<b>CASE#</b> <b>2011-COA-281(IRV)</b>	<b>INDIANAPOLIS HISTORIC PRESERVATION COMMISSION</b> <b>STAFF REPORT</b>	Hearing Date <b>SEPTEMBER 7, 2011</b>
<b>354 S. ARLINGTON AVENUE IRVINGTON</b>		<i>NEW CASE</i>
<b>Applicant</b> <b>FRED &amp; CHERYL WILLIG</b> mailing address: 354 S. Arlington Avenue Indianapolis, IN 46219		Warren Township Council District: 21 Benjamin Hunter
<b>Owner: SAME AS ABOVE</b>		
<b>EXPEDITED CASE</b>		
<b>IHPC COA: 2011-COA-281</b> Enlarge rear addition <b>(IRV)</b>		
<b>STAFF RECOMMENDATION: Approval</b>

**To approve a Certificate of Appropriateness to enlarge the second story rear addition per the submitted documentation and subject to the following stipulations:**

**North façade existing and proposed**

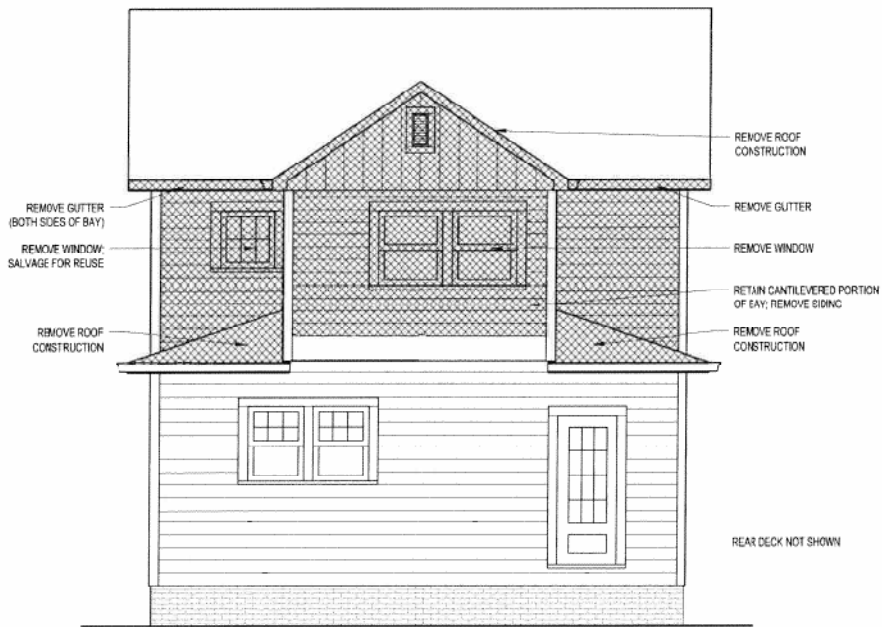
The design of the proposed addition is in scale with the existing building. It will have some visibility from S. Arlington. The roofline created will be a full-length gable and will retain a cantilevered bay. The bay's roof will change from a gable to a shed roof form, and is designed to mimic another bay on the north façade. If possible, several of the original windows will be reused. If they cannot be reused, new wood double hung windows will be installed.

- *Additions and accessory buildings should be discernable as a product of their own time.*  
The corner board trim on the north and south facades is being retained to differentiate the new addition from the historic building. This, paired with a band board and lower rear gable roofline on the rear façade, sympathetically differentiates the new construction.

- 1) **Siding and trim materials shall match that on the main house.**
- 2) **Window units may be salvaged from the existing structure or may be new all-wood windows with appropriate dimensions and detailing. New windows must be approved by staff prior to installation.**  
**Staff Initials: \_\_\_\_\_ Date: \_\_\_\_\_**
- 3) **All exposed wood shall be pre-finished or painted.**
- 4) **Any changes to the approved scope or design shall be approved by IHPC staff prior to starting work.**
